**Railroad Square - Development Master Plan**

**CBDC Development Plan –Submittal #7 – Final Development and Subdivision Plan Submission  
(Map 37 Lots 28 and 29-00A)**

**TURNING MOVEMENTS –FIRE APPARATUS**

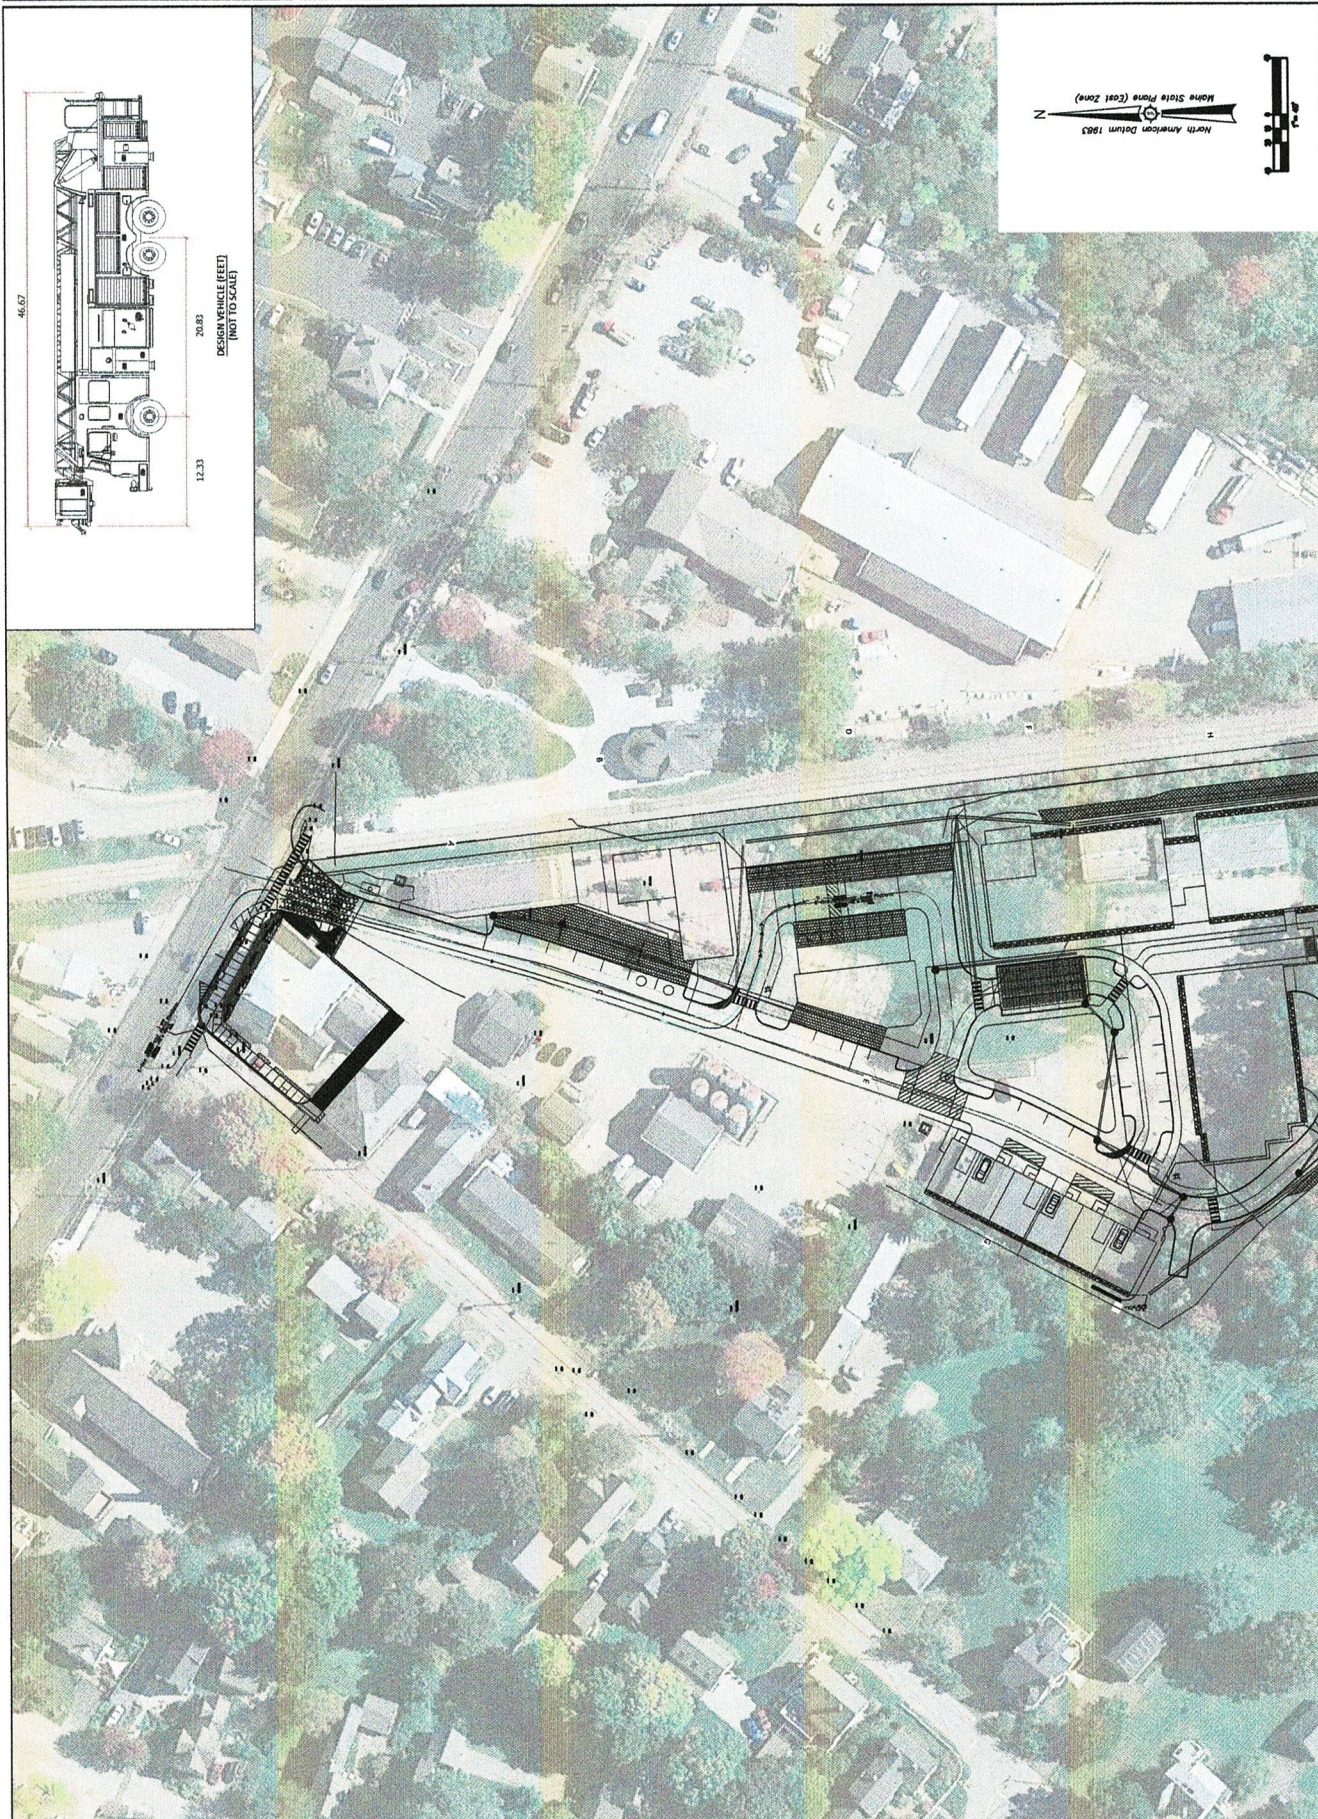
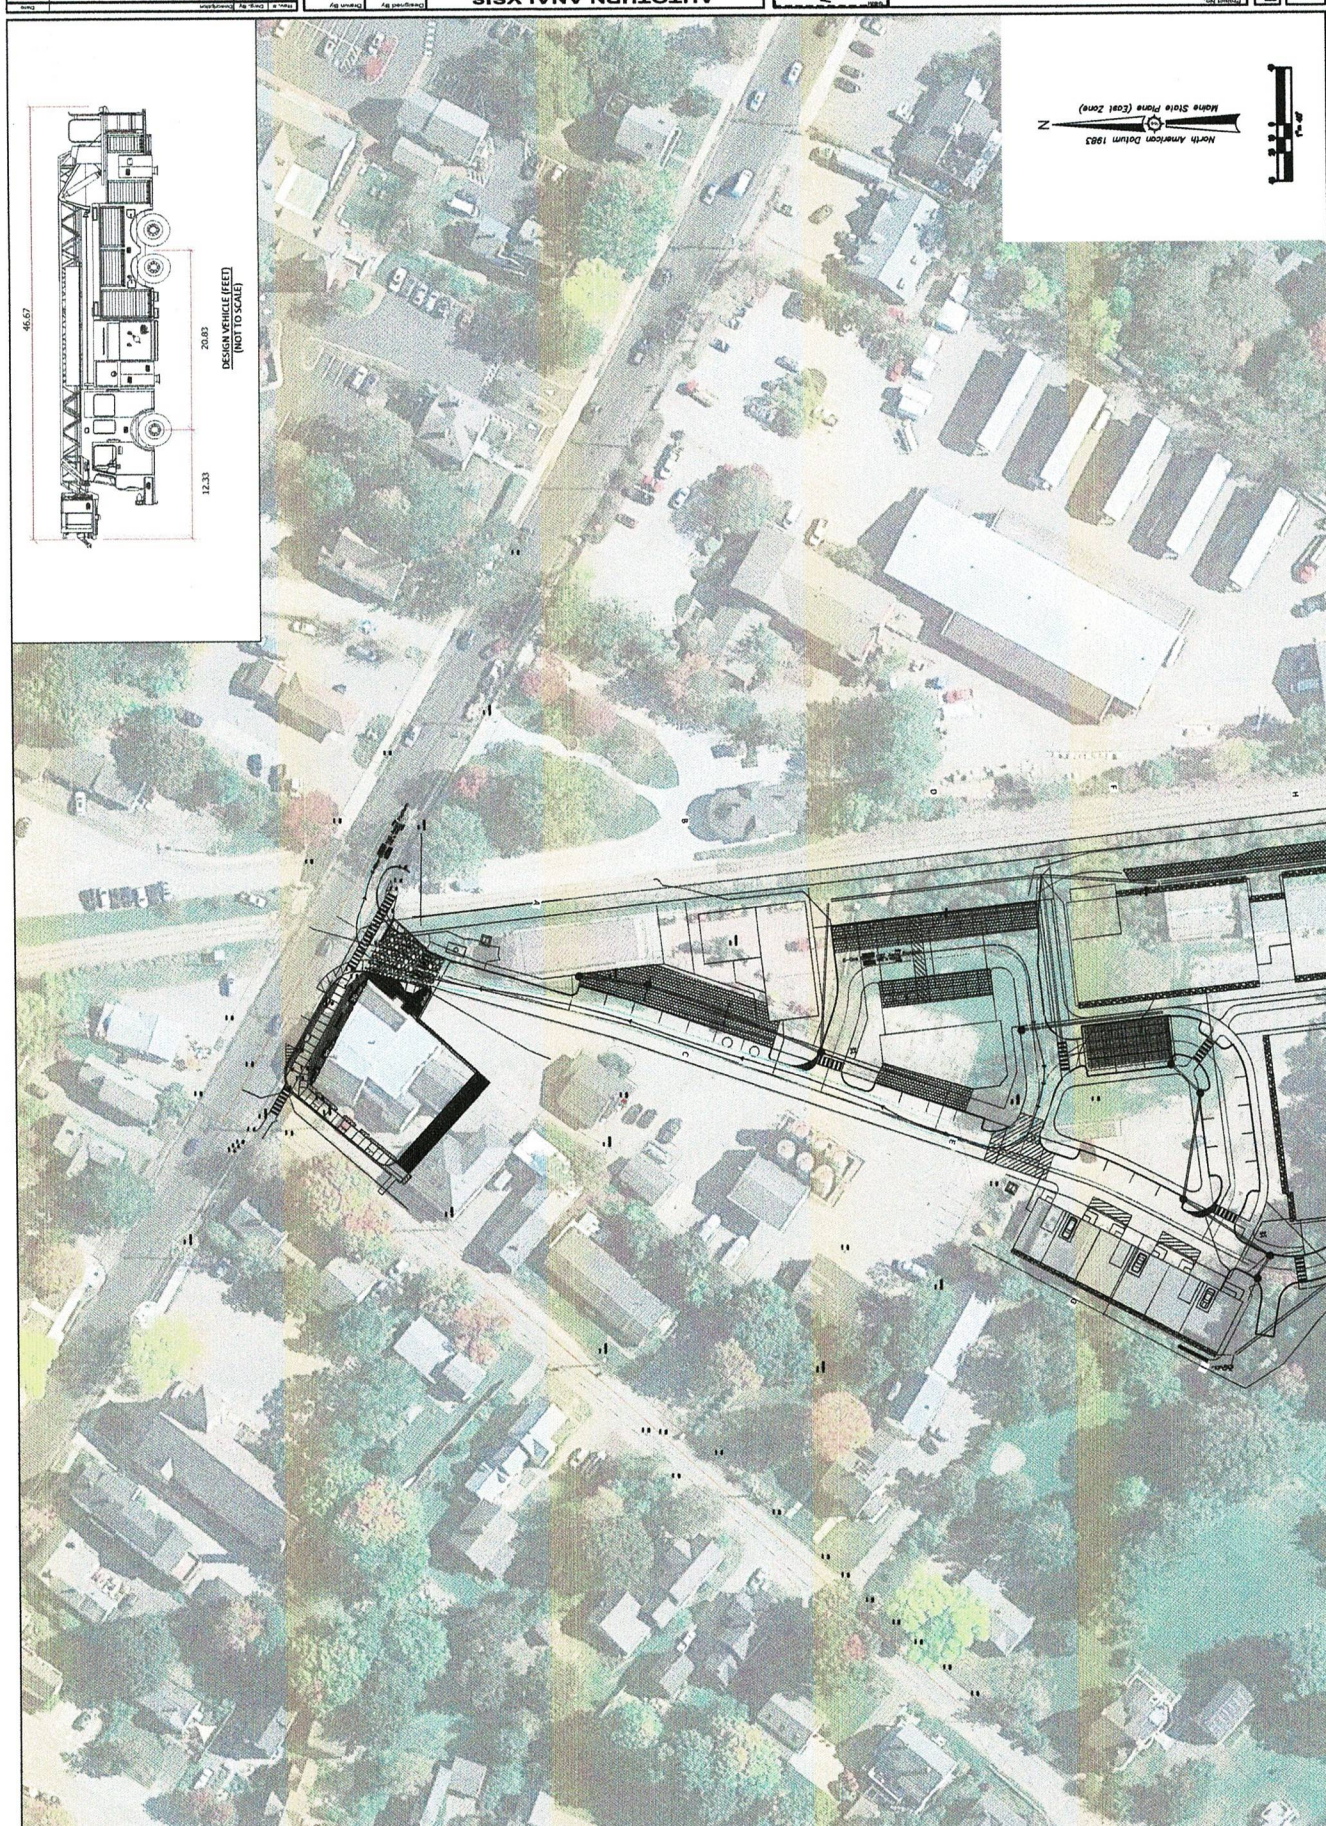
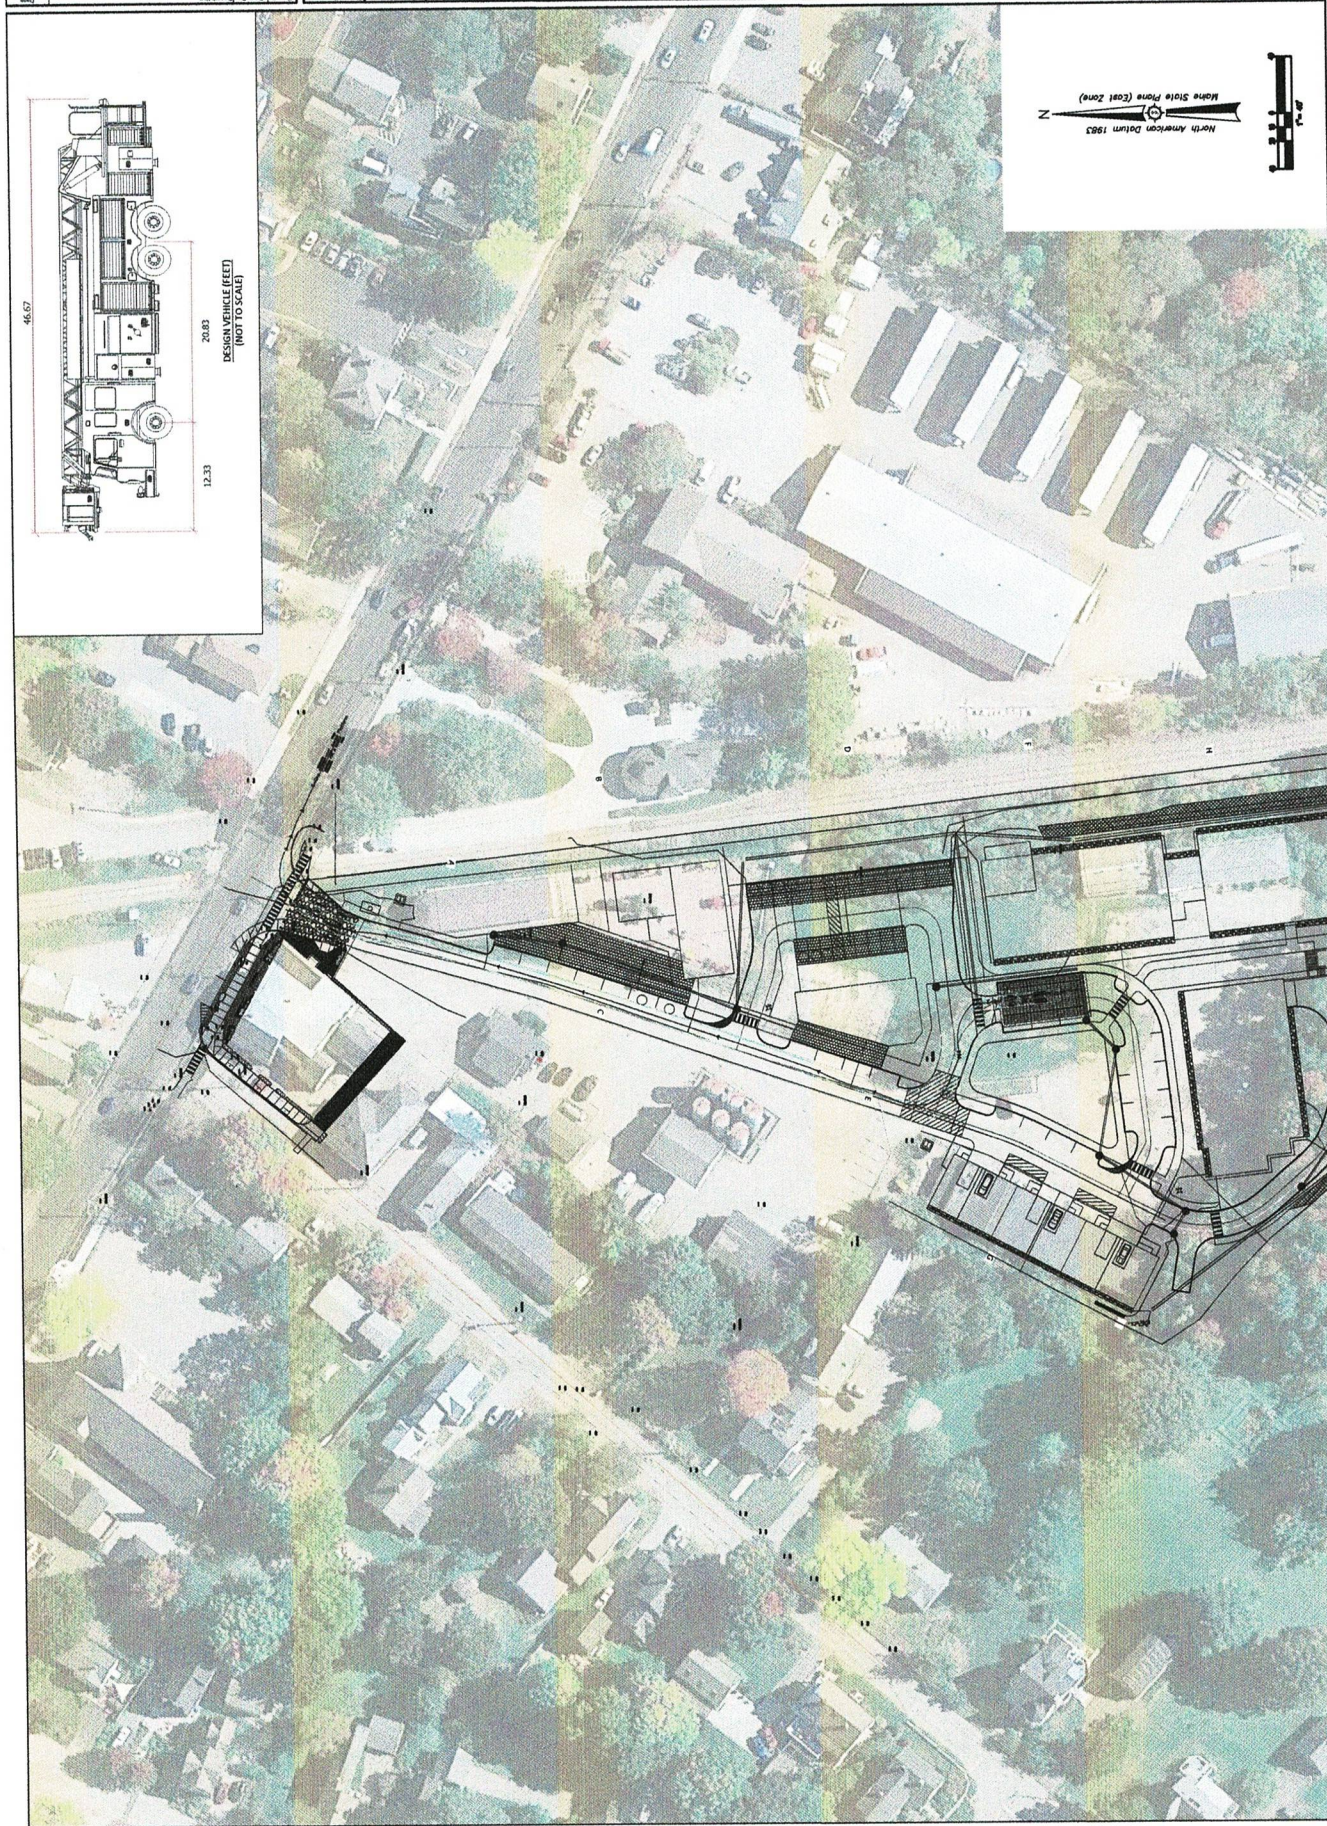
- n. Vehicle Turning Movements –Prior submissions included large truck turning movement templates. We have also added for additional clarity the Fire Department ladder truck (similar model) turning movement templates. Refer to *Exhibit 6*.
